**RE: Marble Townhomes
Grading Plan and Drainage Report
Engineer's Stamp Date: 01/24/18
Hydrology File: J18D046**

RE: Marble Townhomes
Grading Plan and Drainage Report
Engineer's Stamp Date: 12/29/17
Hydrology File: J18D046

**MARBLE TOWNHOMES
6001 MARBLE NE
Albuquerque, New Mexico**

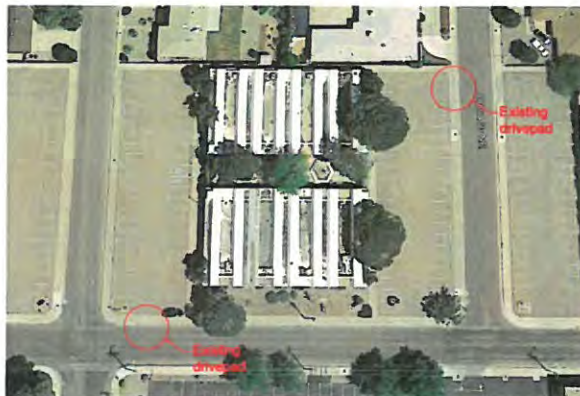
1. The site currently shows more than 1 acre of disturbance is being proposed. An Erosion and Sediment Control Plan is required and has to be submitted to the storm water quality engineer (Curtis Cherne, PE, ccherne@cabq.gov). Hydrology's approval for Grading or Building Permit will not be given until the submittal of the ESC Plans. **ESC was prepared and submitted**
2. Please provide a note showing the first flush required volume and the first flush provided volume. **We have shown this in the calculation table**
3. Please provide a typical detail for the turned CMU block. This block needs to be at least four (4) inches above the proposed grade to avoid clogging.
we have added detail
4. There are two missing remove drivepad & replace with curb & gutter note as outlined in the following photo.
we have incorporated the additional existing drivepads

MARBLE TOWNHOMES
GRADING AND
DRAINAGE PLAN

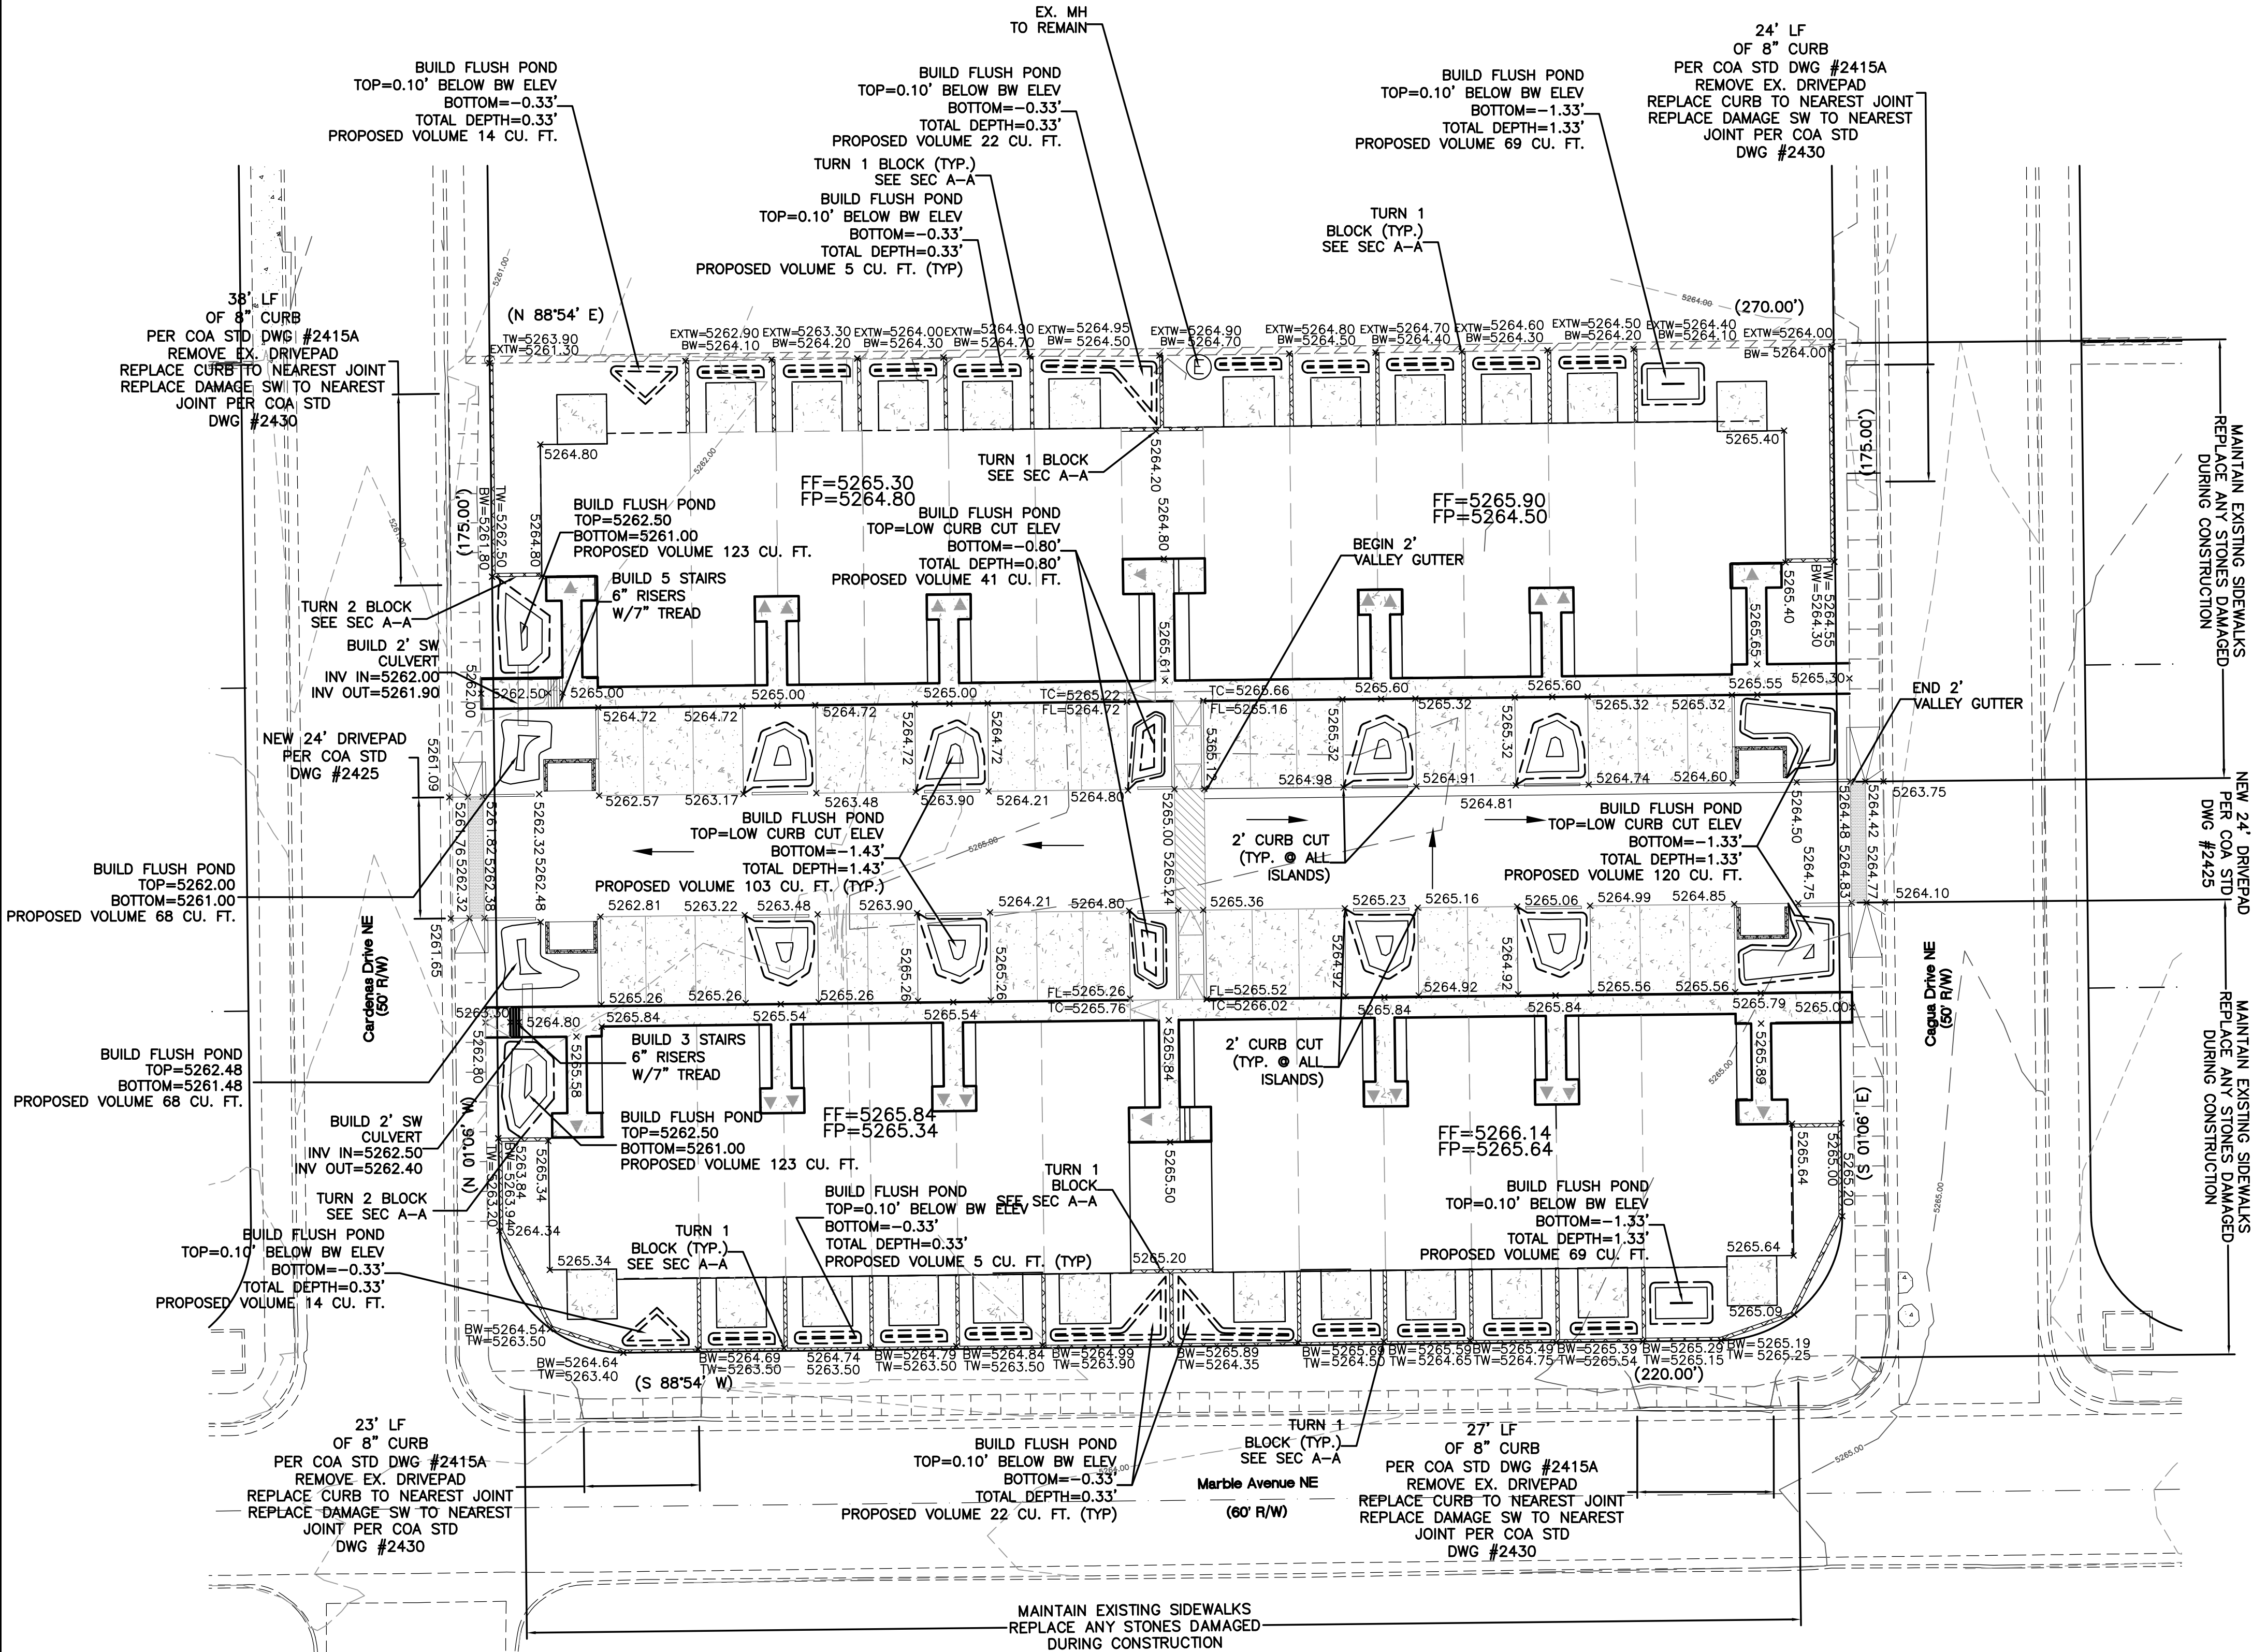
1. Under the Existing Conditions, it appears that about half of the site drains to Cardenas Drive and about half of the site drains to Cagua Drive with a small portion draining directly to Marble Ave. Please take another look at the existing conditions.

2. Provide a drainage map for the Existing Conditions and update the existing drainage calculations.

3. Under the Proposed Conditions, why not keep the drainage as per the appeared drainage conditions as outlined in #1 above?

We have modified the existing conditions map

We have added updated map and corrected existing drainage calculations

We have modified the plan to better match the correct existing conditions
